Determination 2024/008

Whether a timber barrier to a retaining wall complies with Building Code clauses F4.3.1 and F4.3.4.

1206B Hikuai Settlement Road

Figure 1: Photograph showing the barrier and layout of the property.

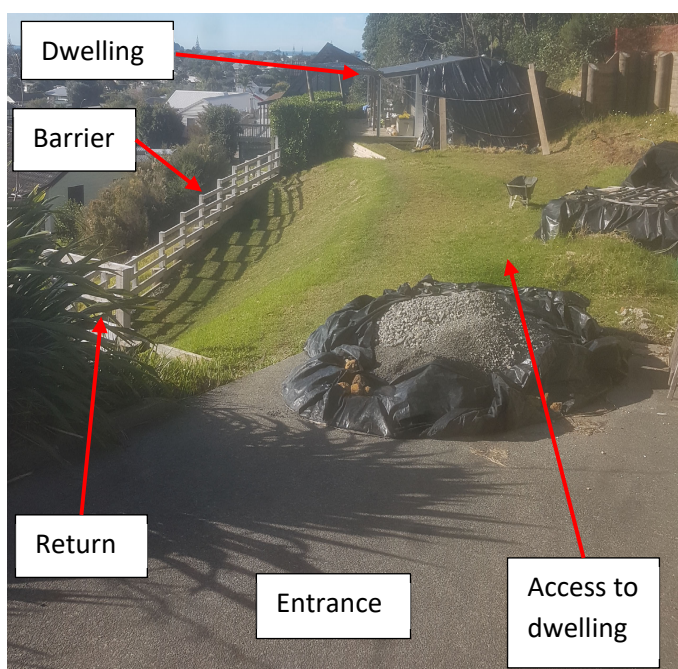
2.1. The barrier in question was constructed at the top of a timber retaining wall on the north side of the property. The barrier is made of vertical timber posts, with three horizontal timber members. The retaining wall supports a lawn area located at the end of a driveway, which provides access to the dwelling (see Figure 1).

- 2.2. I note that this determination does not consider the return at the western end of the barrier, as it is not clear whether there is a fall of 1m or more associated with that section of the barrier.
- 2.3. The height of the barrier to the ground level varies due to the stepped nature of its construction relative to the sloping ground. Dimensions provided by the applicant confirm its height at the central section of the barrier to be 930mm, with the gaps between horizontal members of 135mm (between bottom rail and top of retaining wall), 205mm and 205mm. See figure 2.

Figure 2: Diagram of barrier construction

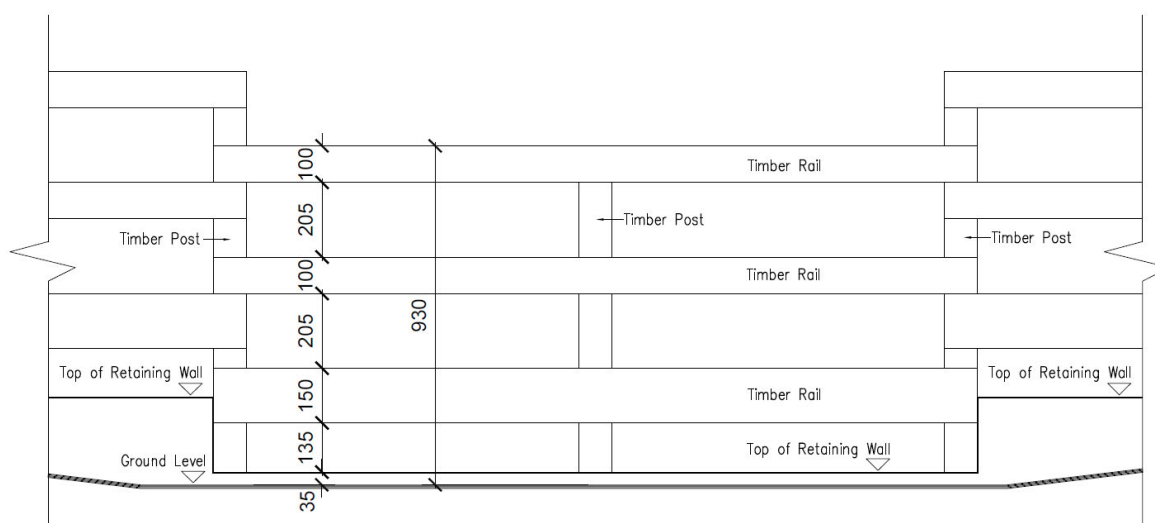
- 5.41. Dimensions provided by the applicant confirm that there are clearances of 135mm, 205mm and 205mm between the retaining wall and the three horizontal members of the barrier, with a maximum vertical dimension between the horizontal members of 208mm. (See figure 2)

- 5.42. In my opinion, the dimensions between the retaining wall and the horizontal members of the barrier provide a readily climbable ladder by which a child could easily make passage up the face of the barrier and over the top.

- 5.44. I am also of the opinion that a gap of 205mm in height extending between the vertical posts allows a child under 6 years of age to pass through the barrier.

- 5.45. For these reasons, I conclude the barrier does not restrict the passage of children under 6 years of age, and therefore does not comply with clause F4.3.4(g).
